**URGENT UPDATE: Field Safety Notice**

**FSCA identifier:** Product Field Action RA2013-083  
**Type of Action:** Field Safety Corrective Action  
**Description:** Triathlon Tibial Alignment Ankle Clamp EM (Instrument)  
**Catalog #:** 6541-2-609  
**Lot #:** All

Triathlon Tibial Alignment Ankle Clamp

Figure 1  
Predicate Design  
Triathlon Ankle Clamp (6541-2-609) Revision G

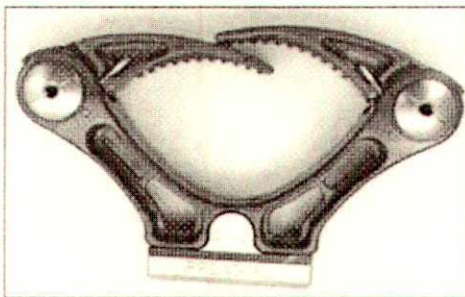
Please note that we have begun the planned transition of RA2013-083 from a Product Correction (see June 2013 Bulletin – lit. ref. TRIATH-BU-3) to a Product Recall. In this second phase of the Action, which will extend into 2015, we will replace all plastic (Rev. G) ankle clamps with metal (Rev. H) clamps. Images of both clamps are provided below for reference.

1. **Do not** return plastic clamps to Mahwah upon receipt of this message – a country-specific replacement schedule will be coordinated by the Knee Business Unit/International Customer Service. As a reminder, replacement activity will extend into 2015. A Stryker Brand Manager will contact your location to begin the exchange process as new design clamps become available.

2. Plastic (Rev. G) clamps can continue to be used in conjunction with the Product Correction Bulletin dated June 28, 2013, until replaced with metal (Rev. H) clamps.
3. The catalog number for the Clamp will not change.

Figure 1

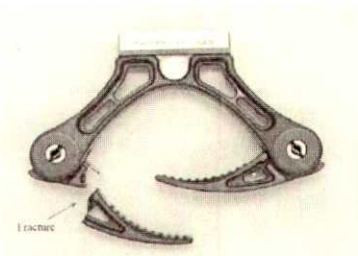
Stryker Orthopaedics has received complaints associated with cracks or fracture of the Triathlon Tibial Alignment Ankle Clamp.

In the event of a fracture of the ankle clamp portion of the tibial alignment assembly at the flipper (figure 1) or at the yolk (figure 2), the instrument will still function as intended.

Figure 3

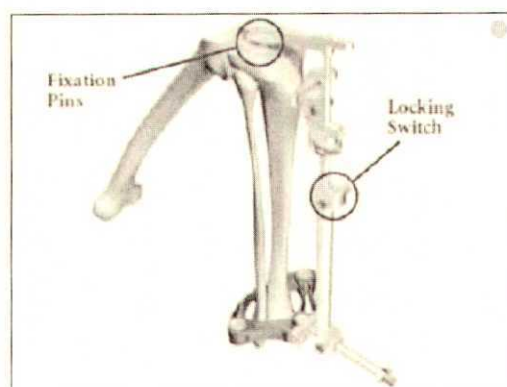
The process will remain the same as defined in the surgical protocol (ref. LSPK47 Rev5). Assemble the Tibial Alignment Ankle Clamp to the Tibial Alignment Distal Assembly EM. In case of a compromised Ankle Clamp, firmly hold the Tibial Alignment Distal Assembly EM and press up to/against the Tibia while maintaining alignment. In accordance with the Triathlon Surgical Protocol, flexion / extension alignment is correct when the long axis of the Tibial Resection Assembly parallels the mid-coronal plane of the tibia. Varus / Valgus alignment is similarly assessed per the established methods. (figure 3)

With a compromised ankle assembly, the surgeon would need to ensure the desired alignment is maintained by holding the assembly in place rather than relying on the stabilization of the ankle assembly. The tibial resection guide would then be pinned in place and the surgeon should proceed with the procedure per the protocol.
